Subject: Compliance Recall 04V-603
(Ford Number 04C10)

SUBJECT: DEMONSTRATION / DELIVERY HOLD: Compliance Recall 04C10
Certain 2005 Model Year E450 Dual Rear Wheel (DRW) Cutaway Vehicles
Vehicle Certification and Incomplete Vehicle Manual Label Correction

SUBJECT: **DEMONSTRATION / DELIVERY HOLD:** Compliance Recall 04C10
Certain 2005 Model Year E-450 Dual Rear Wheel (DRW) Cutaway Vehicles
Vehicle Certification and Incomplete Vehicle Manual Label Correction

FIGURE 1

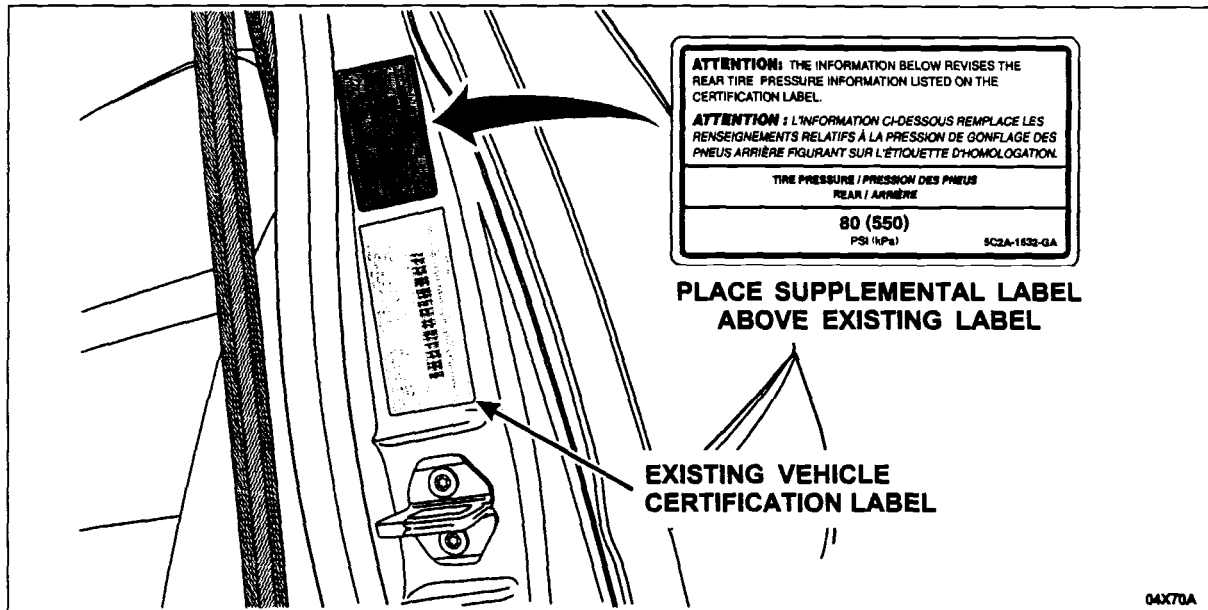
1. Locate and clean the area above the safety certification label on the driver door B-Pillar. DO NOT remove the original label.
2. Install one of the *new* supplemental labels on the vehicle above the existing label as shown in Figure 1. Do not cover the existing label.

FIGURE 2

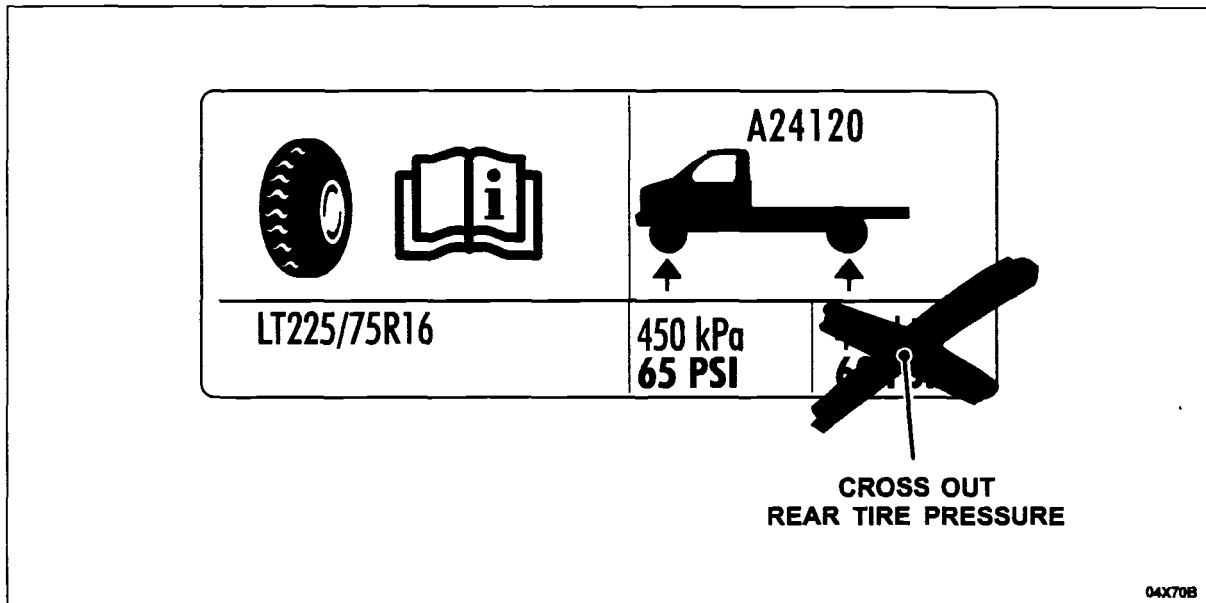
1. Locate the shipping bag containing the Tire Inflation Reminder Label and Incomplete Vehicle Manual.
2. Place the Supplemental Rear Tire Inflation Reminder Label in the shipping bag for installation by the body builder during the final assembly (conversion) process.
3. Remove the original Tire Inflation Reminder Label from the bag and using a black permanent marker, cross out the rear tire inflation pressure, then place the label back in the bag. See Figure 2.

FIGURE 4

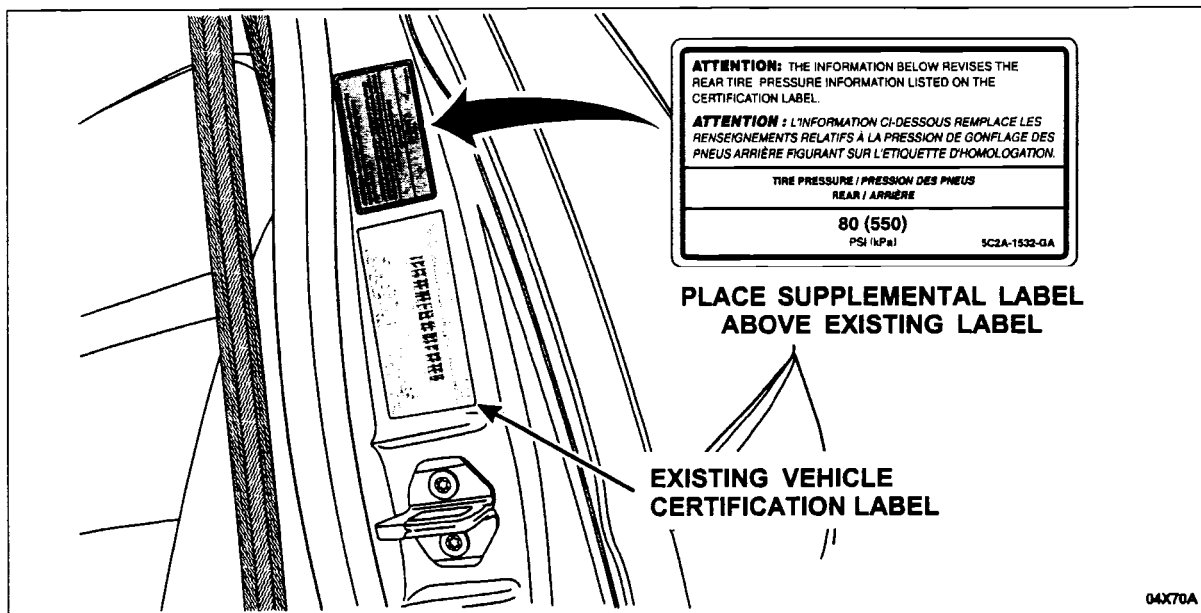
1. Locate and clean the area above the safety certification label on the driver door B-pillar. DO NOT remove the original label.
2. Install one of the **new** supplemental label on the vehicle above the existing label as shown in Figure 4. Do not cover the existing label.

FIGURE 5

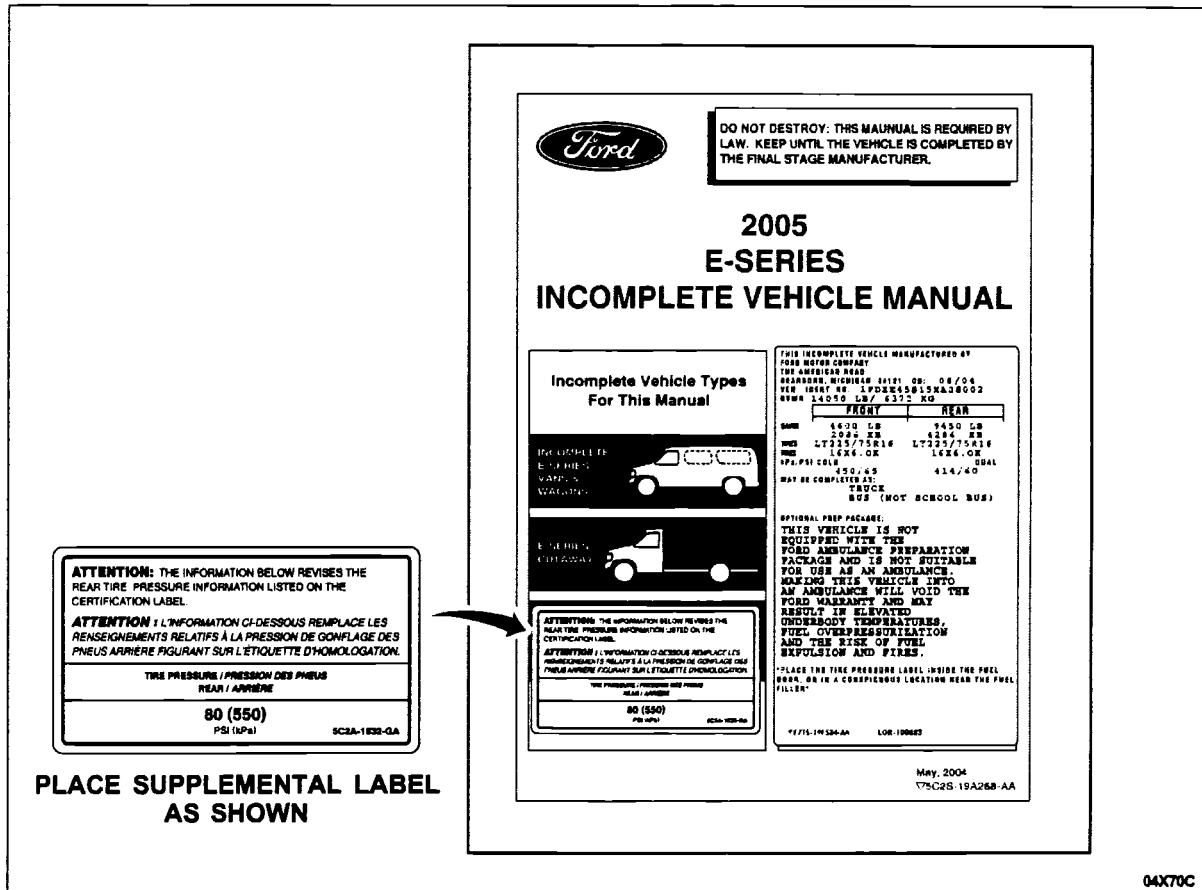
1. Locate the shipping bag containing Incomplete Vehicle Manual.
2. Affix the second Supplemental Incomplete Vehicle Manual Label on the cover of the manual as shown in Figure 5.
3. Replace manual back in the shipping bag and stow it back in the vehicle.

FIGURE 6

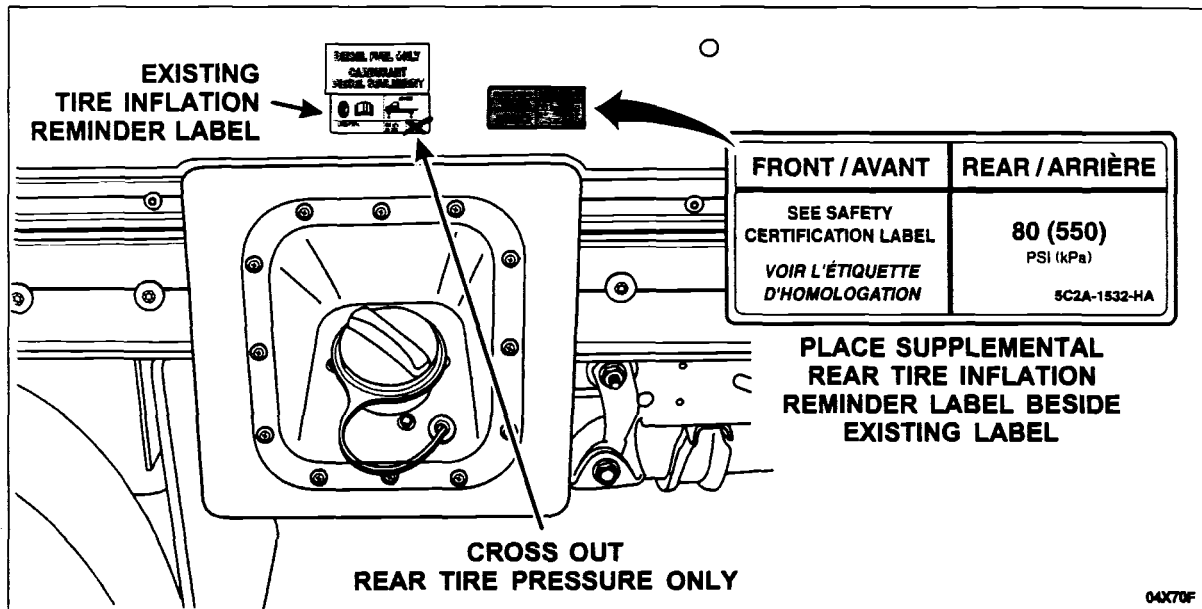
4. Affix the Supplemental Rear Tire Inflation Reminder Label on the body of the truck adjacent to the original Tire Inflation Reminder Label. See Figure 6.
5. Using a black permanent marker, cross out the rear tire inflation pressure on the existing Rear Tire Inflation Reminder Label. See Figure 6.
